CLIENT
Barni & Patrizia Askaro

PROJECT NO.
19xsy011

ADDRESS
4 Loch Maree
Vaucluse
NSW 2030

TITLE 3D View_Figure 15
Revised Built Form
Lowered 800mm

TITLE 3D View_Figure 16
Revised Built Form
Lowered 800mm

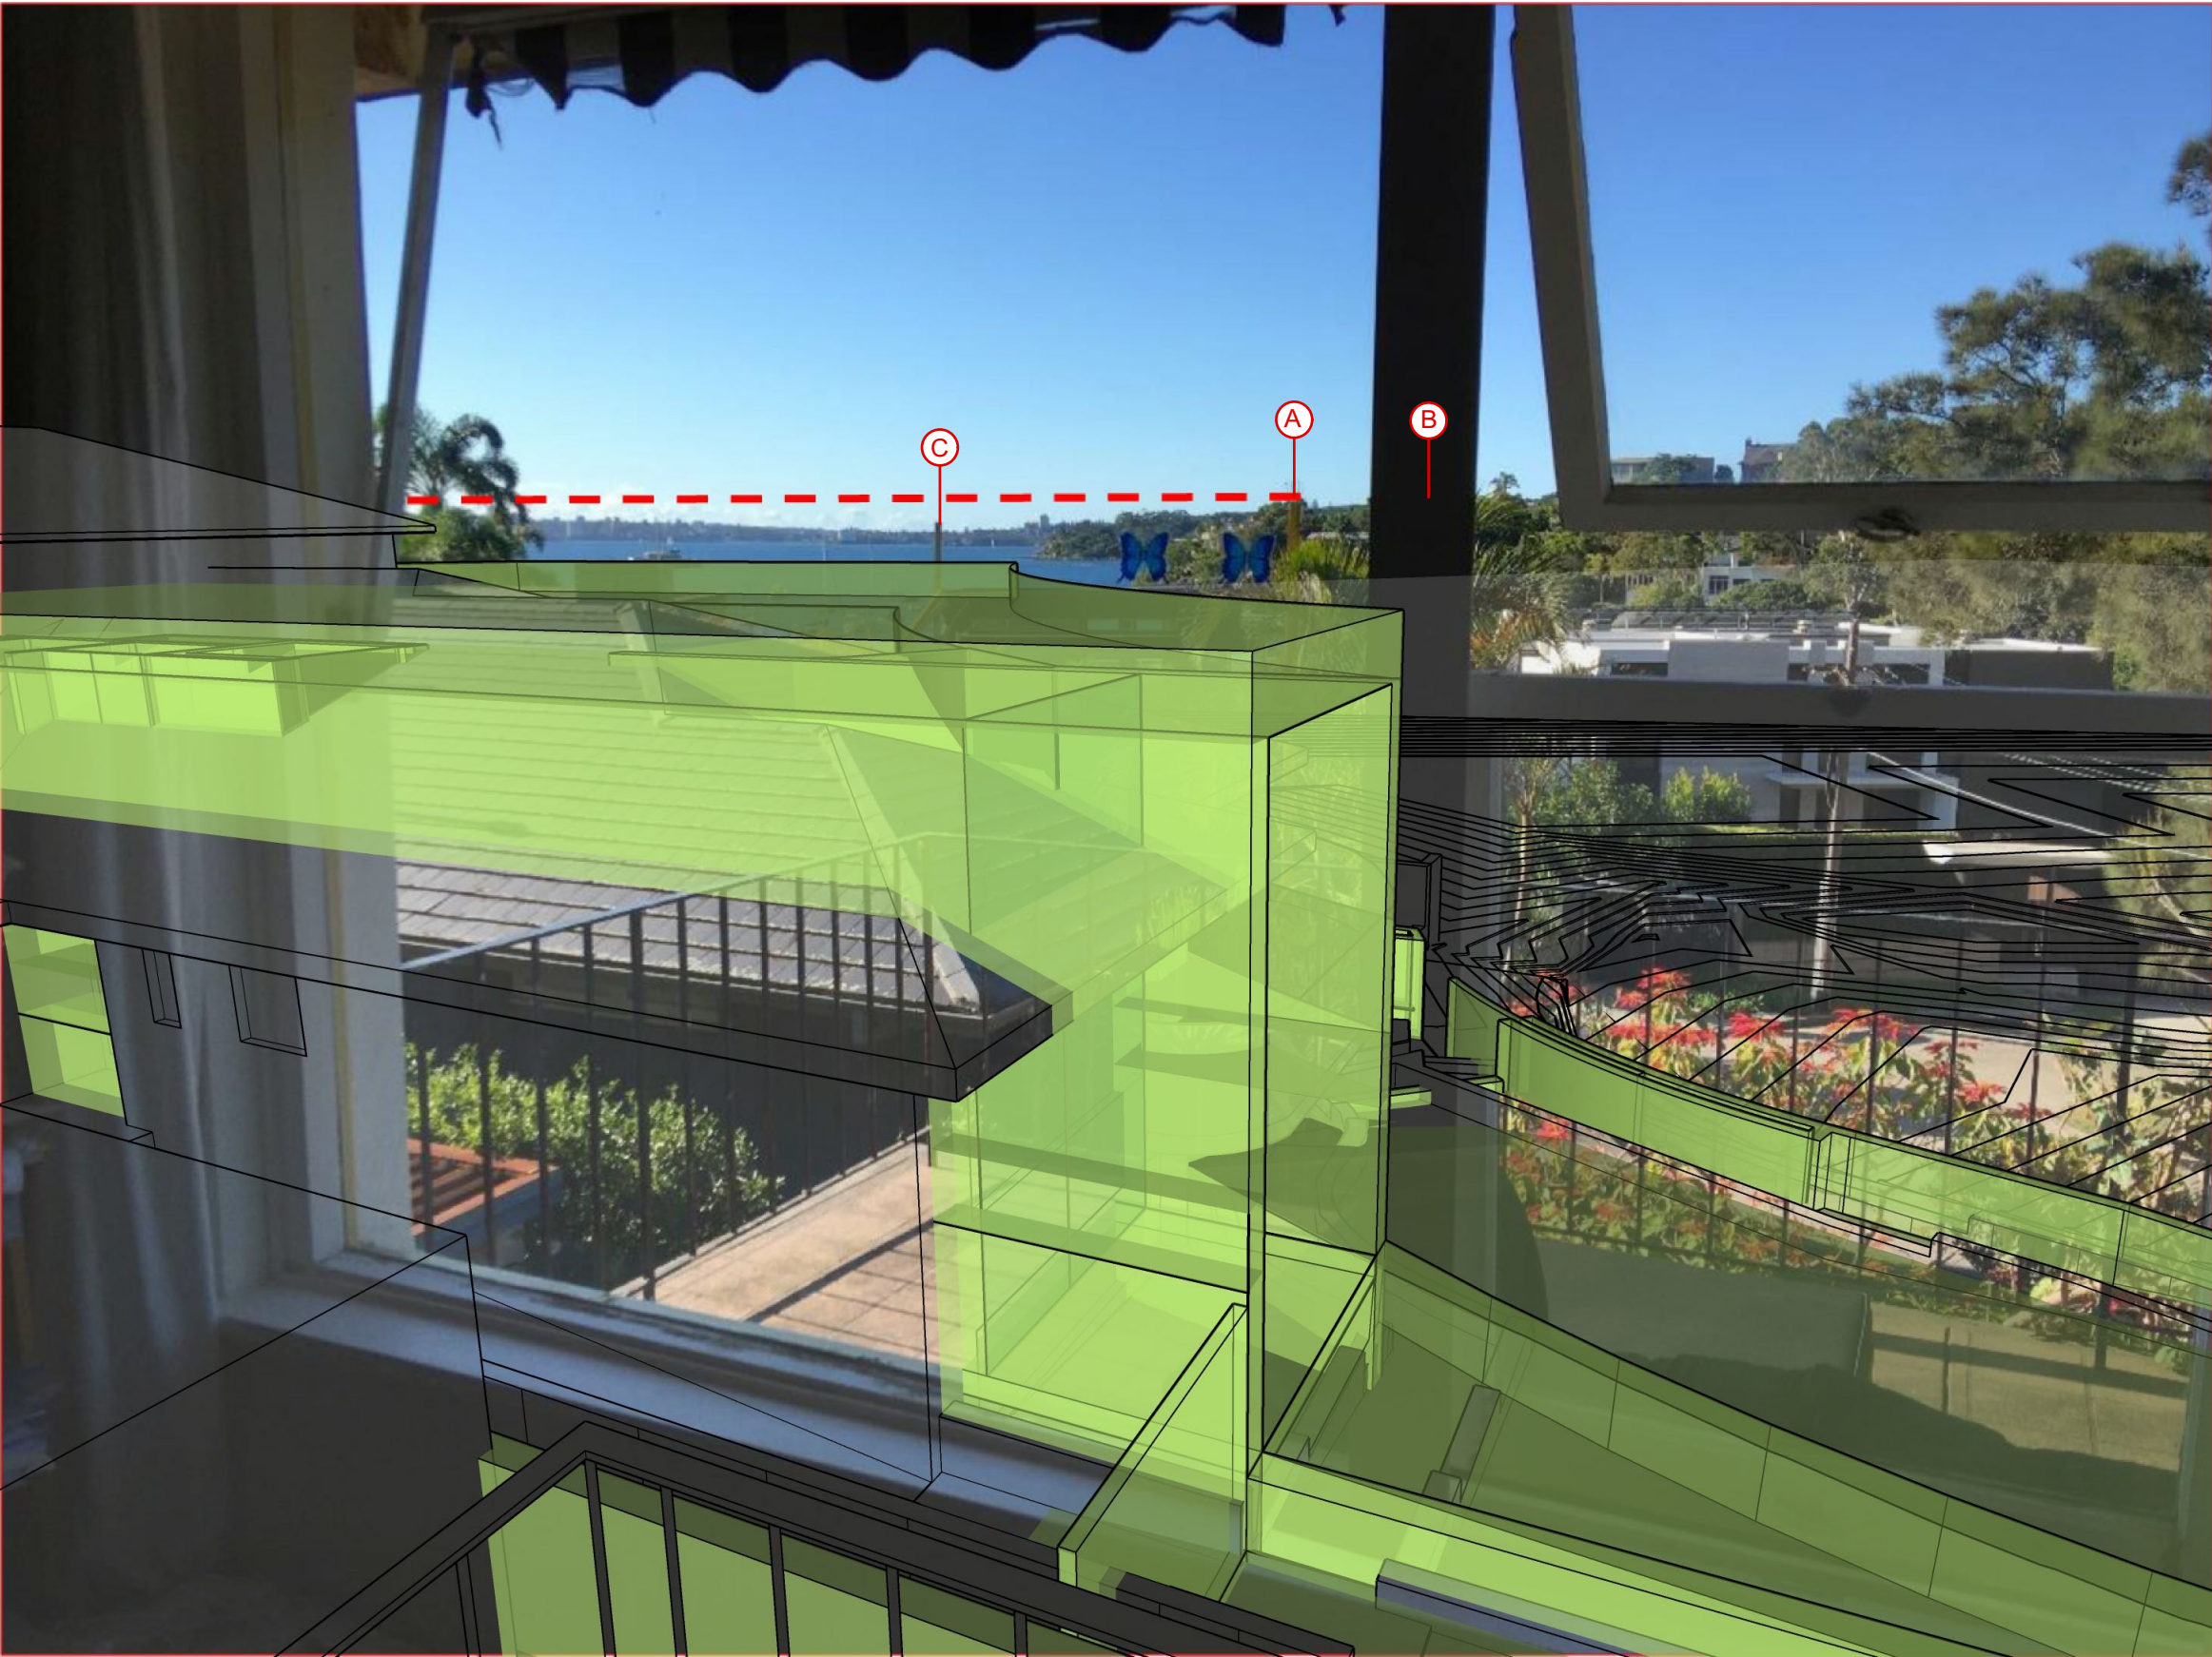
- note:**
1. Revised built form southern boundary setback at 2700 [previous south setback was 3400]
 2. Driveway stormwater requires pump out station for building lowered 800mm

TITLE 3D View_Figure 17
Revised Built Form
Lowered 800mm

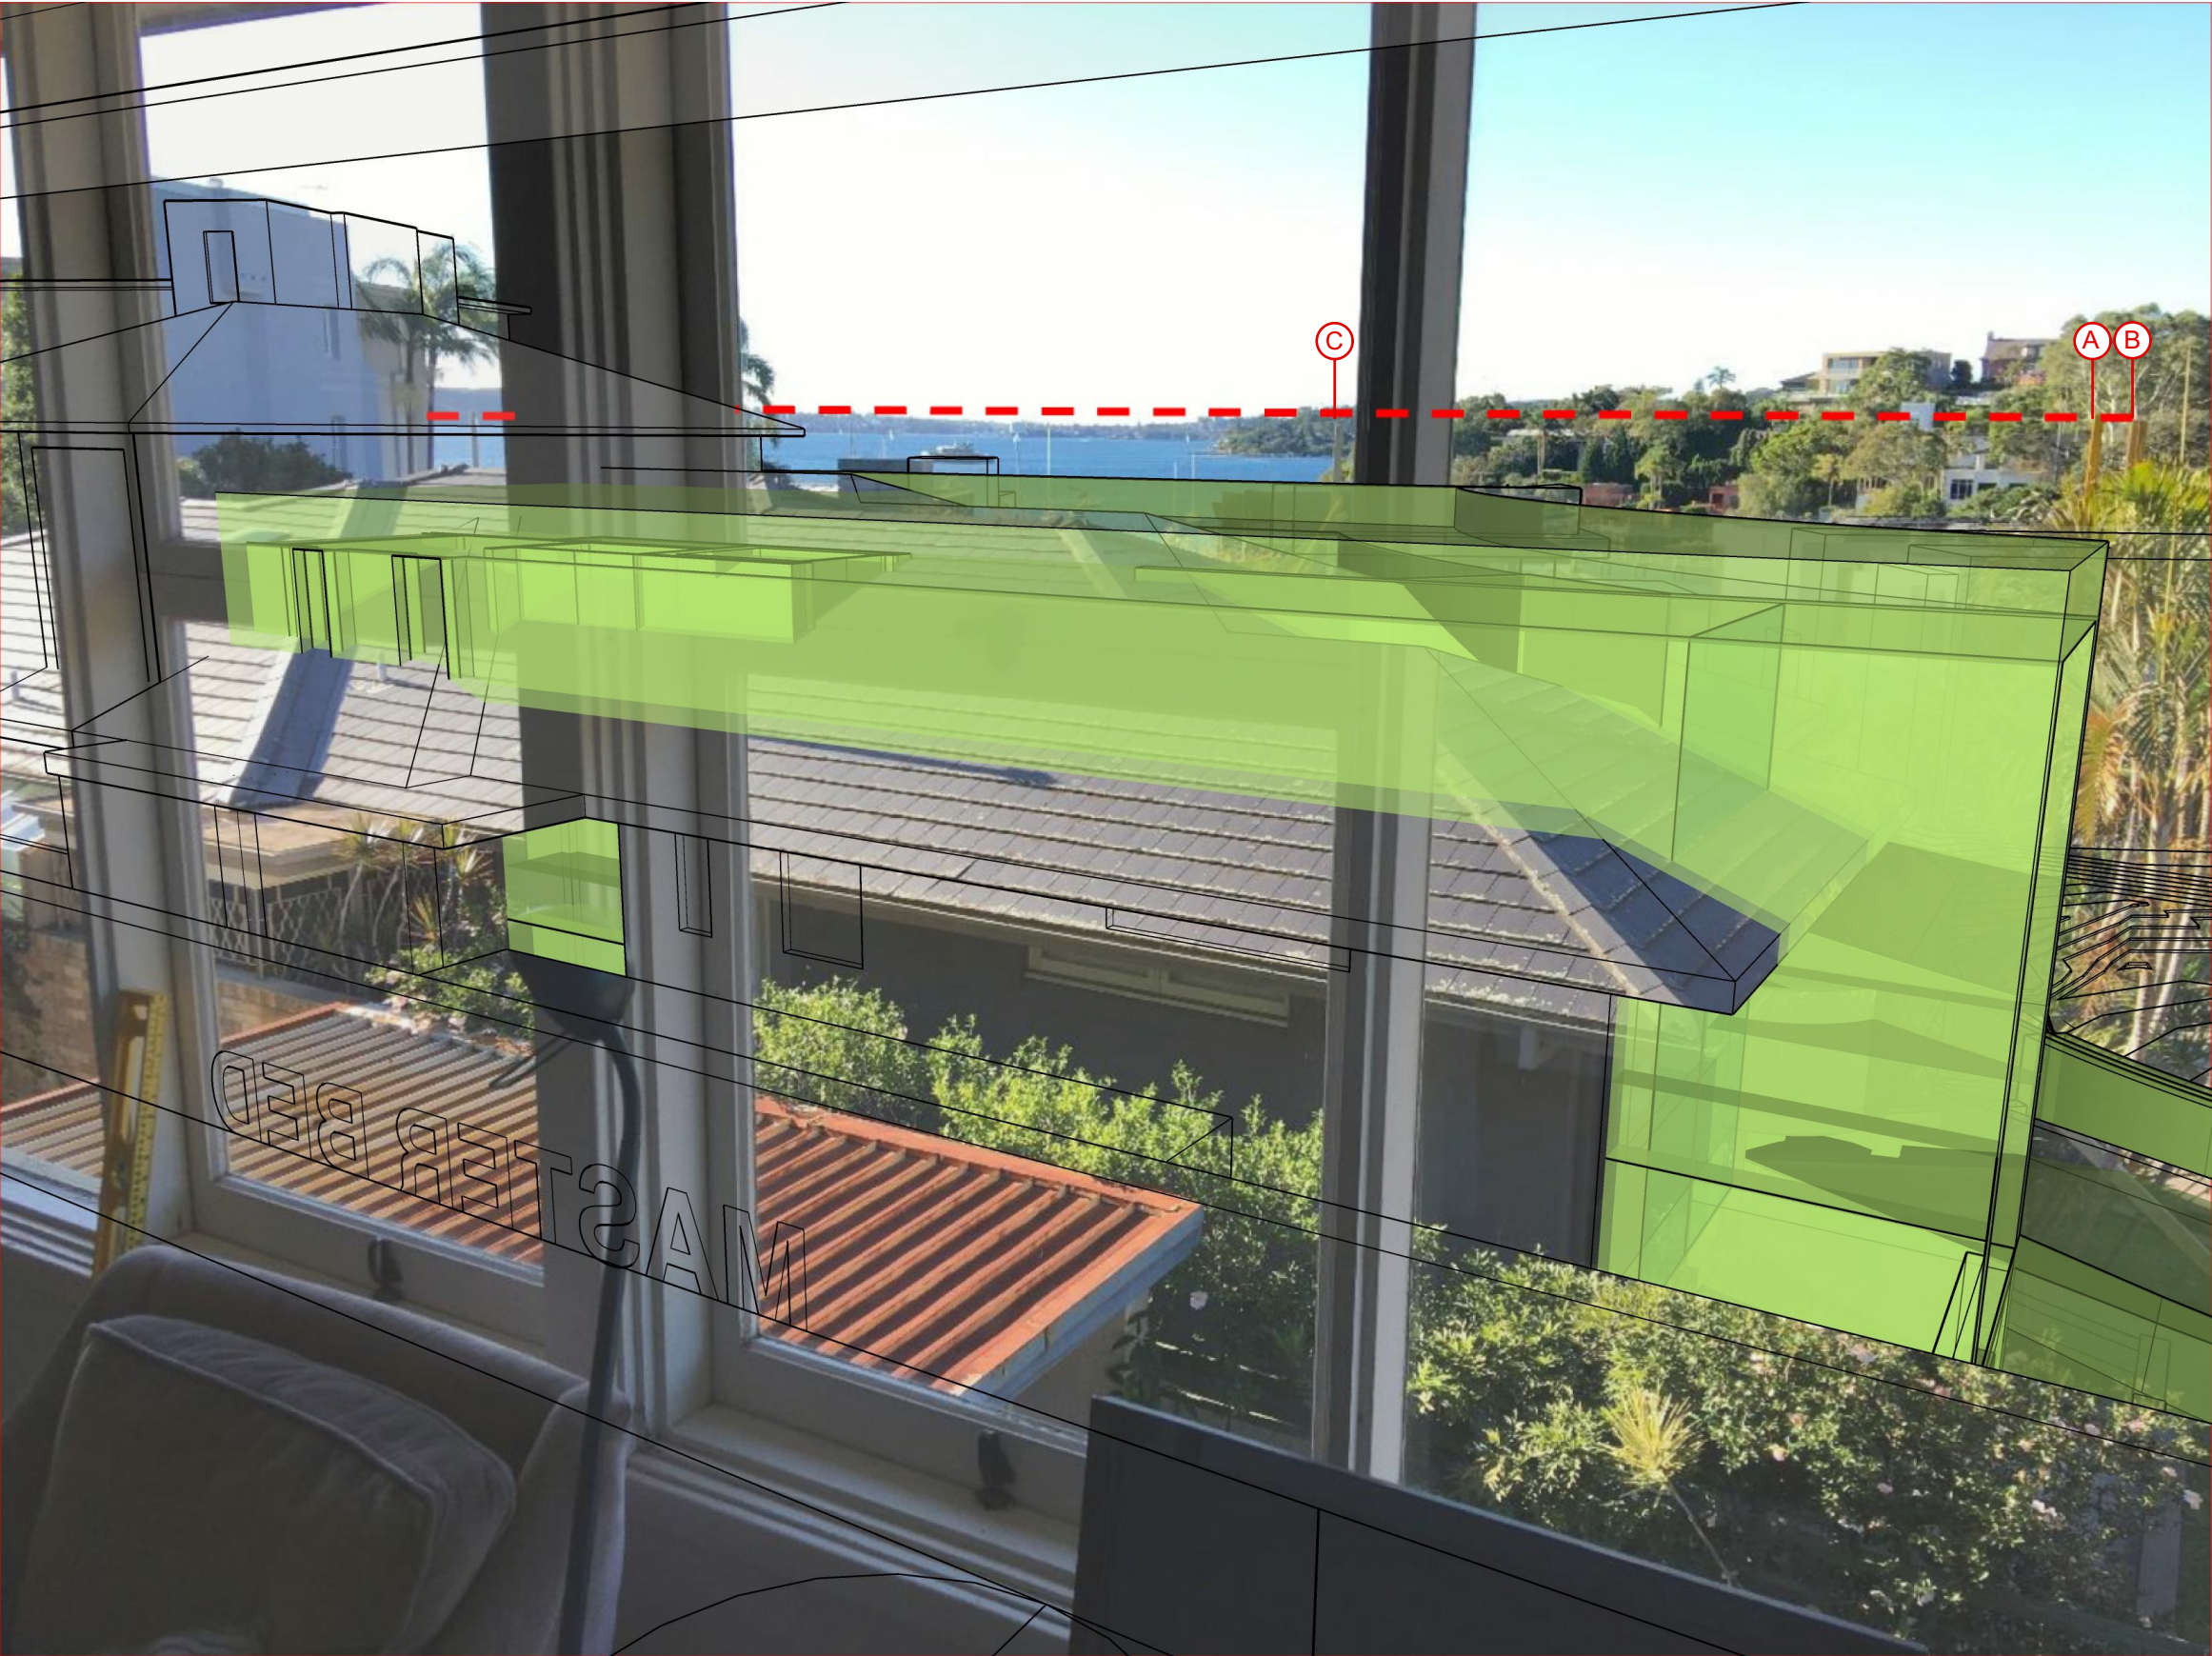
- note:**
1. Revised built form southern boundary setback at 2700 [previous south setback was 3400]
 2. Driveway stormwater requires pump out station for building lowered 800mm

TITLE **3D View_Figure 18
Revised Built Form
Lowered 800mm**

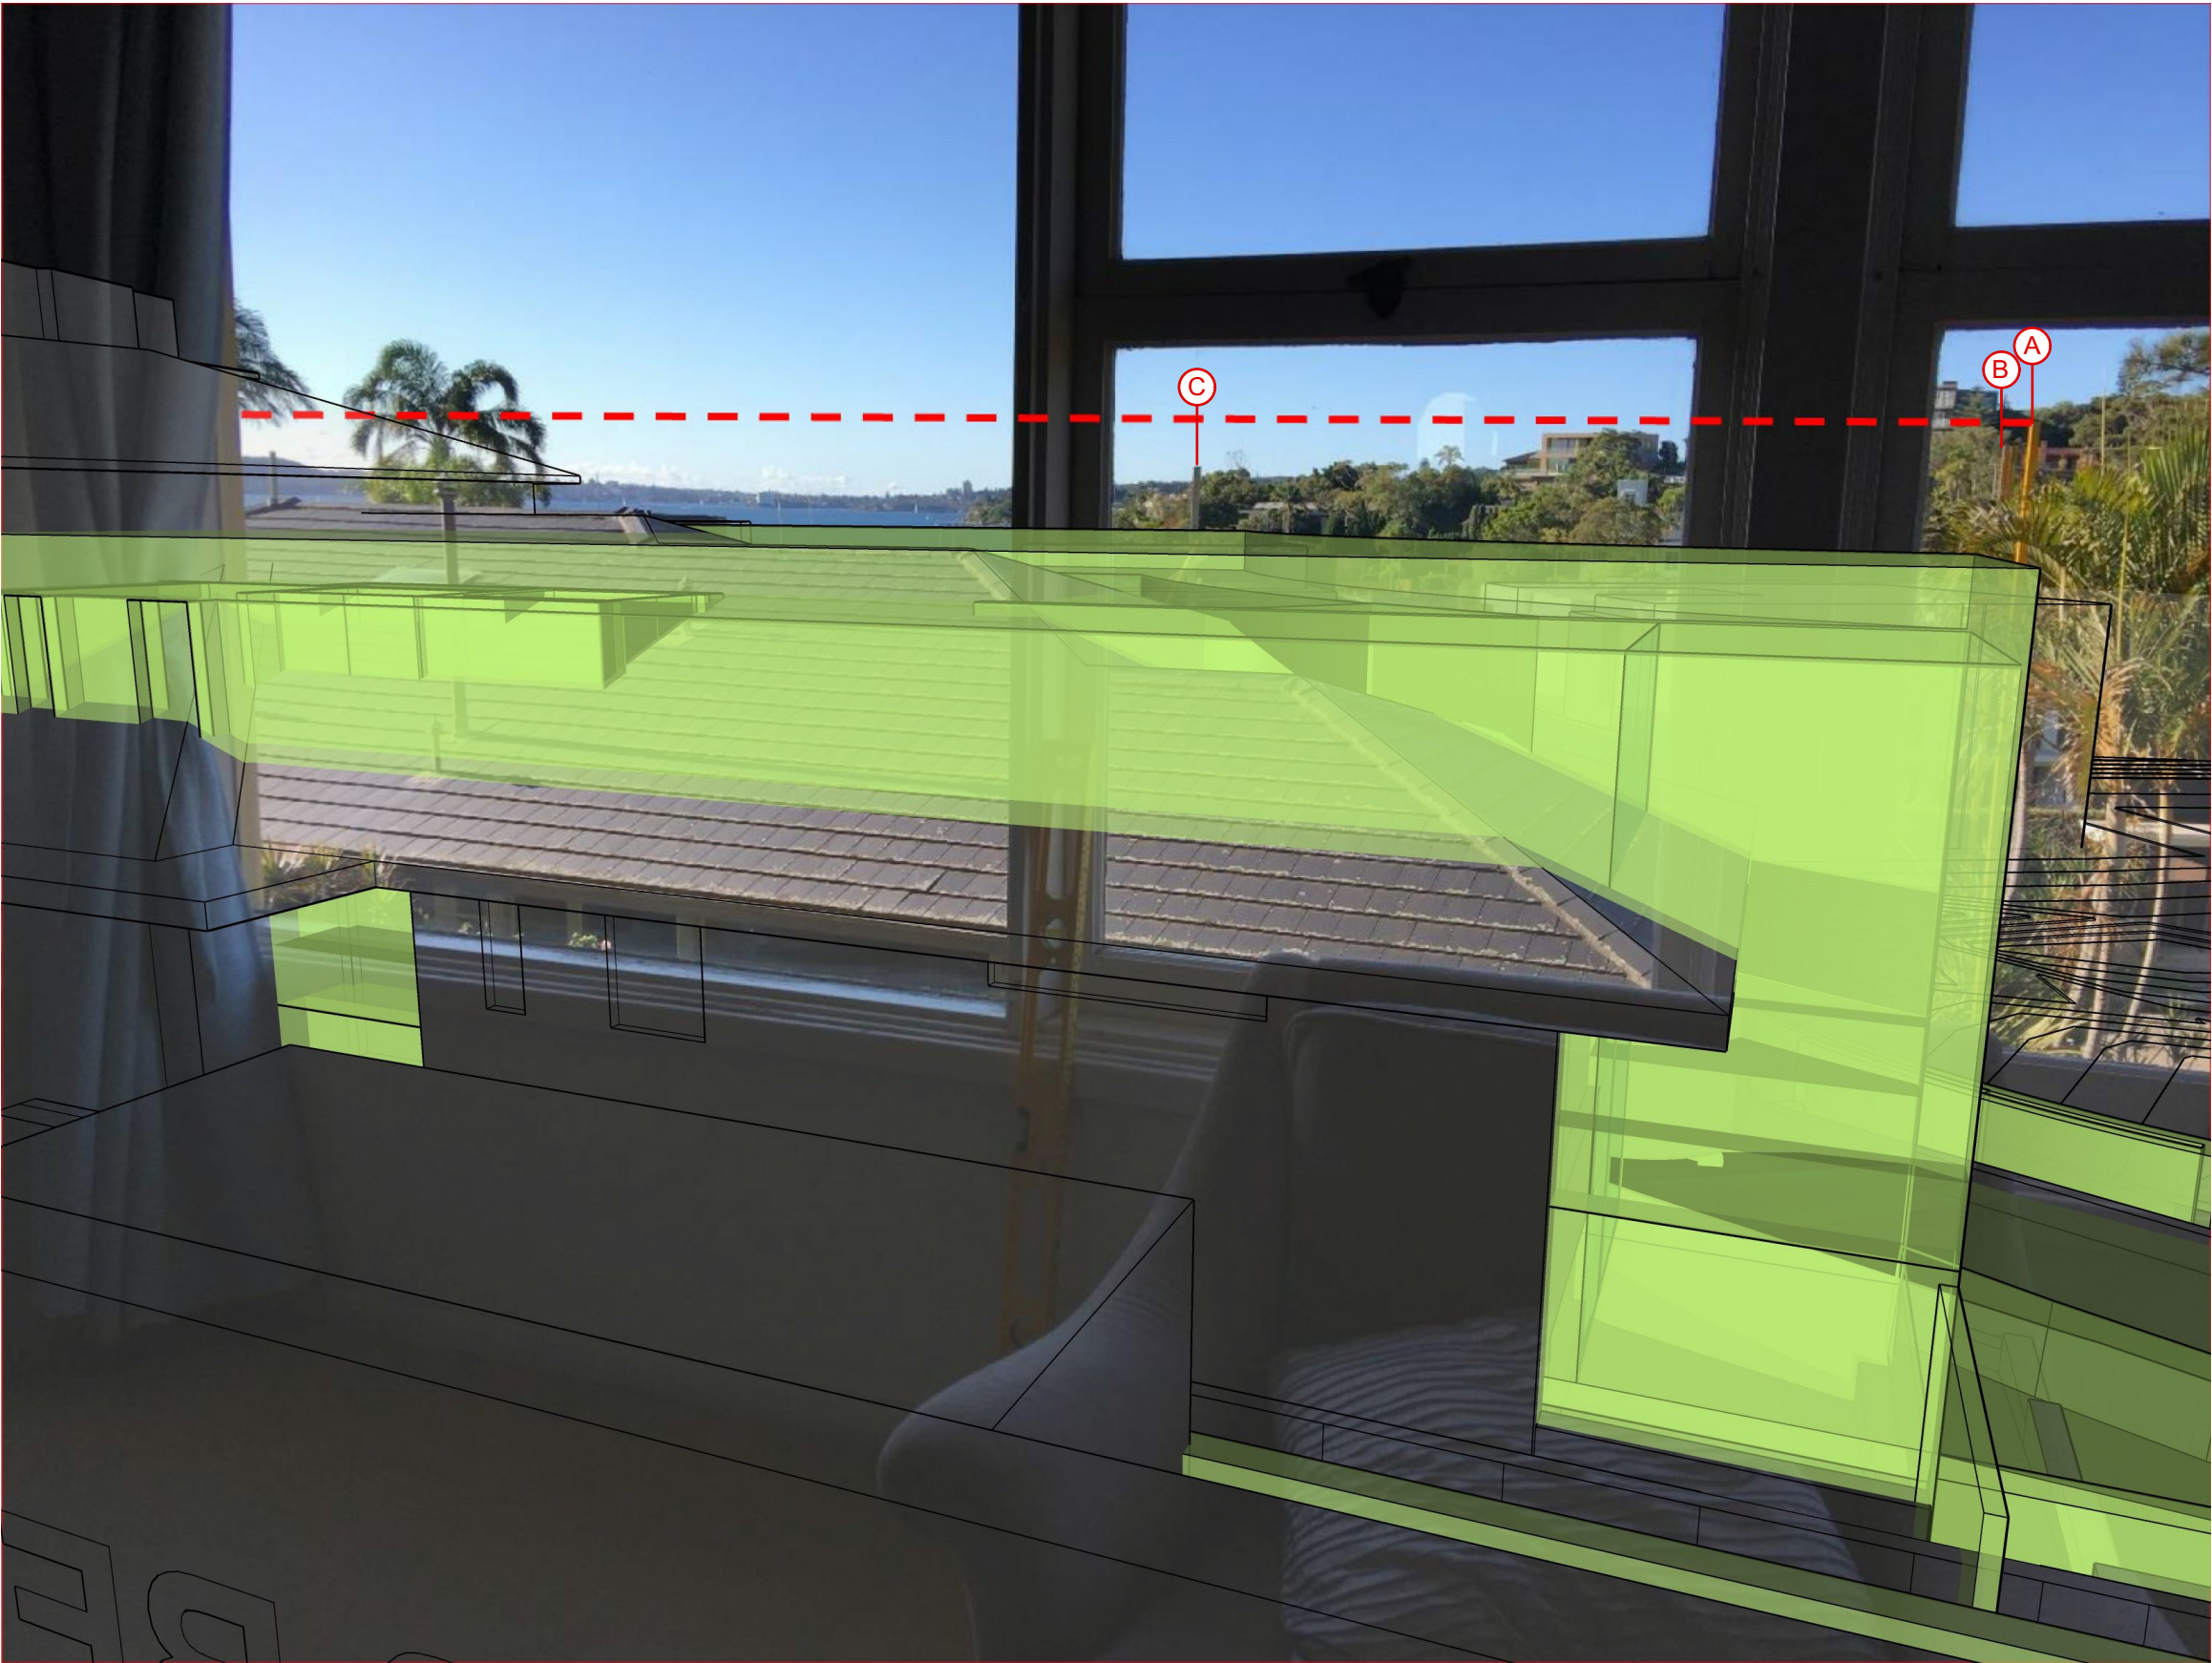
1. Revised built form southern boundary setback at 2700 [previous south setback was 3400]
2. Driveway stormwater requires pump out station for building lowered 800mm
